**HISTORIC LANDMARK COMMISSION
STAFF REPORT**

**Loewen Addition
Major & Minor Alterations
(Second Public Hearing)
PLNHLC2011-00214
545 E 900 S
September 1, 2011**

PLAN A

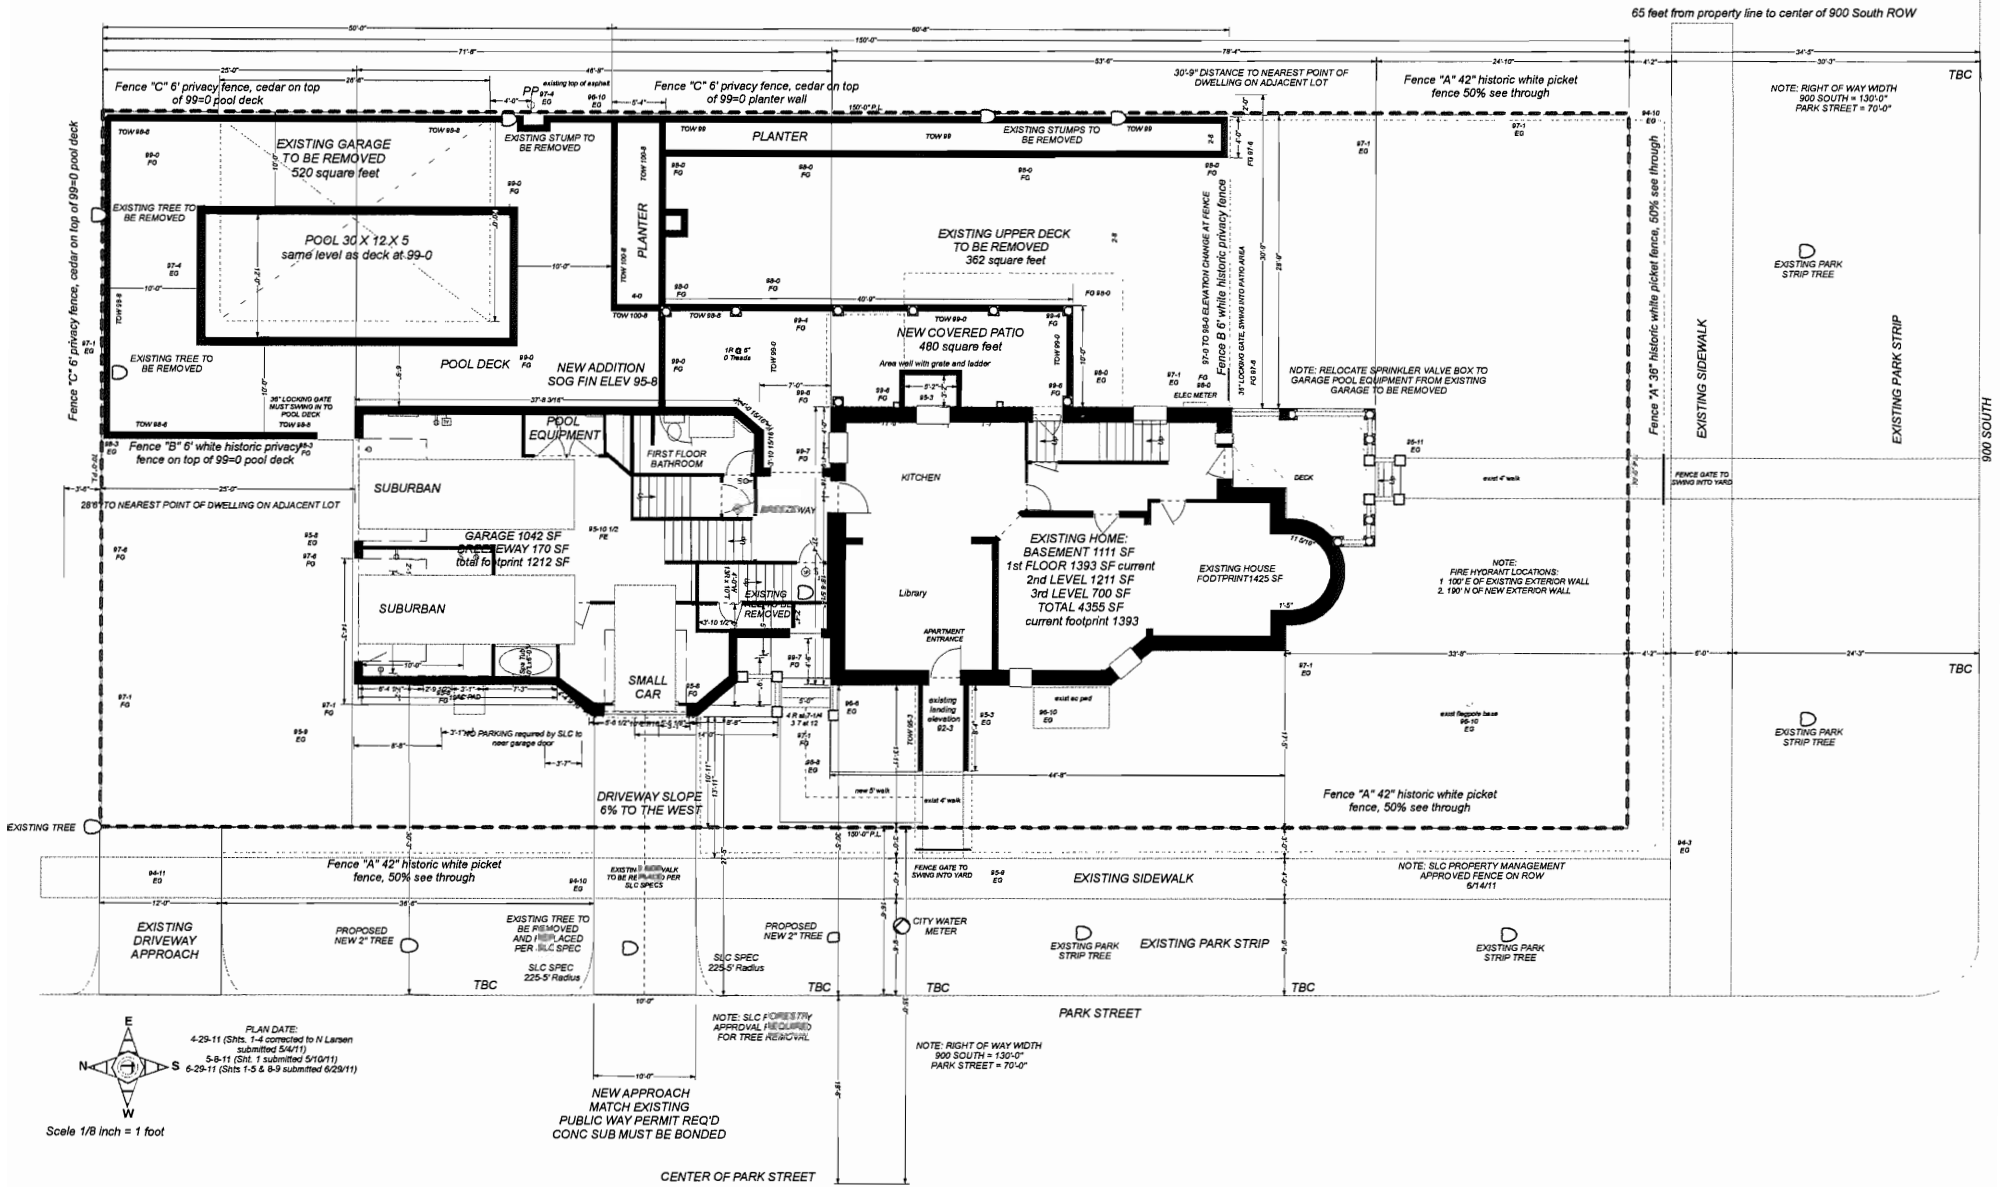
- ‘A’ not much different from original, slightly more detailed.
- ‘B’ most preferable to Commissioner Davis, more visual interest than option C.
- Dropping the roofline on option B might reduce the appearance of the mass.
- ‘C’ is too plain and may look more massive with such plain detailing.
- ‘D’ looks to be too much building coverage on the lot.

PLAN B

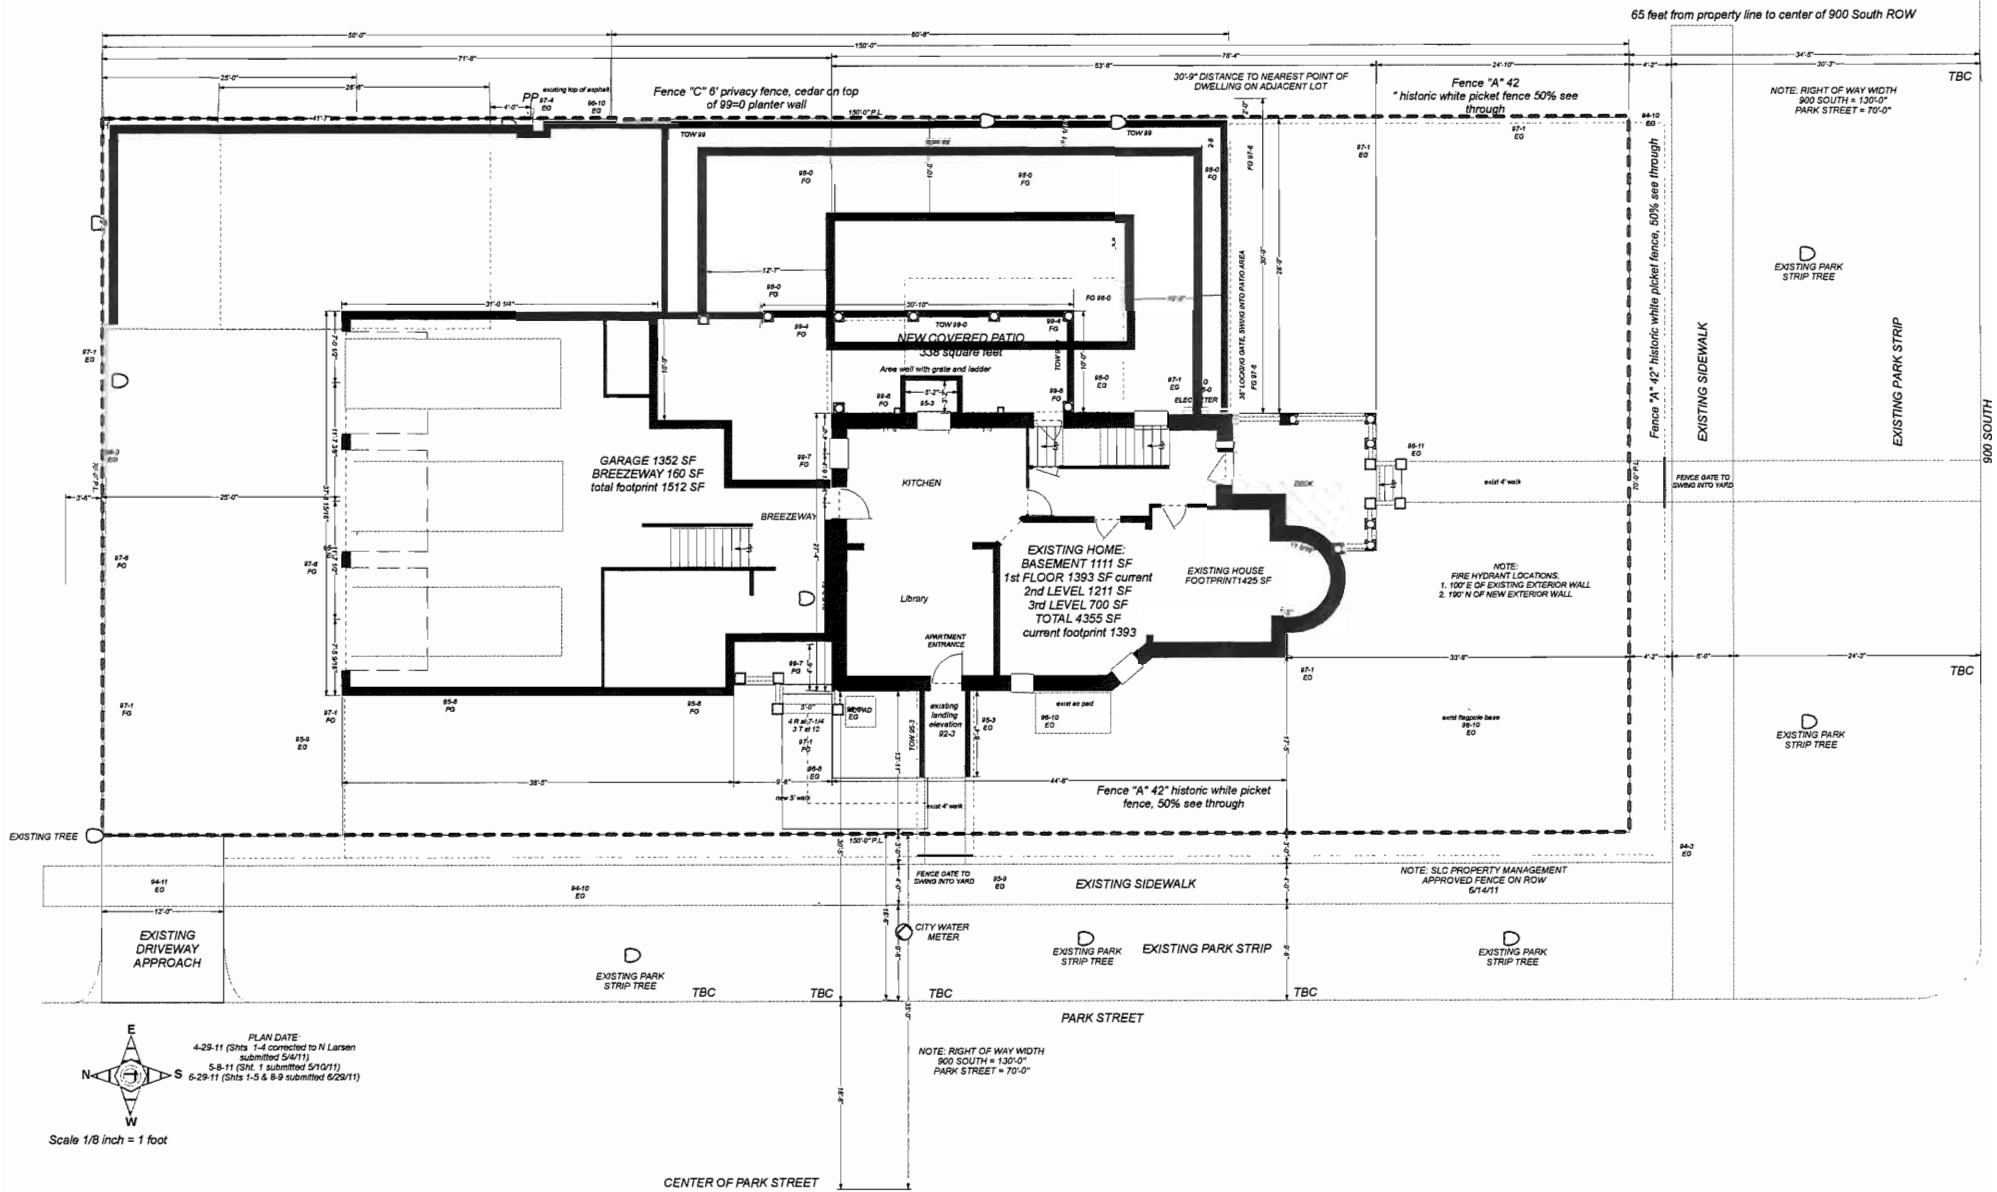
Mr. Loewen expressed that he preferred option B and would rather construct an attached than detached garage.
